8.1 **DA 2014/349 - 16 Lot Subdivision Amber Drive, Lennox Head.DOC**

**RE: Proposed Subdivision of Lot 42 DP 1168665 Amber Drive (DA 2014/349)**

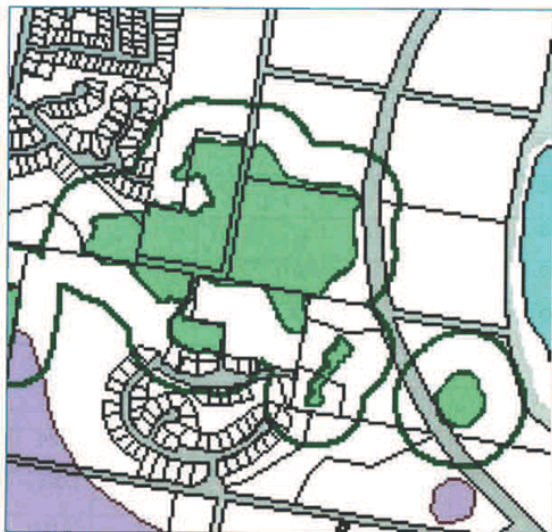
It is noted that Council is particularly interested in the proposed dwelling envelope and access driveway for proposed Lot 13, which is now shown and located further south clear of vegetation. It should be noted that there is existing strong precedent for dwellings to be located within 100m of SEPP 26 rainforest (particularly along Castle Drive and Kelli Ann Crescent). Council rezoned land to the south of the SEPP 26 rainforest (No 37, 37B and 37C) on Kellie Ann Cres to R3 Medium Density Residential under the Ballina LEP 2012, which is well within the 100m. We feel there is a need for consistent and equitable housing policy within SEPP 26 buffer.

Blackwood Ecology has also considered the future development of Lot 13 including a building envelope and future access way. They conclude that future development can occur without the need to remove any native vegetation from within the SEPP 26 area or its associated buffer, which covers the majority of this lot.
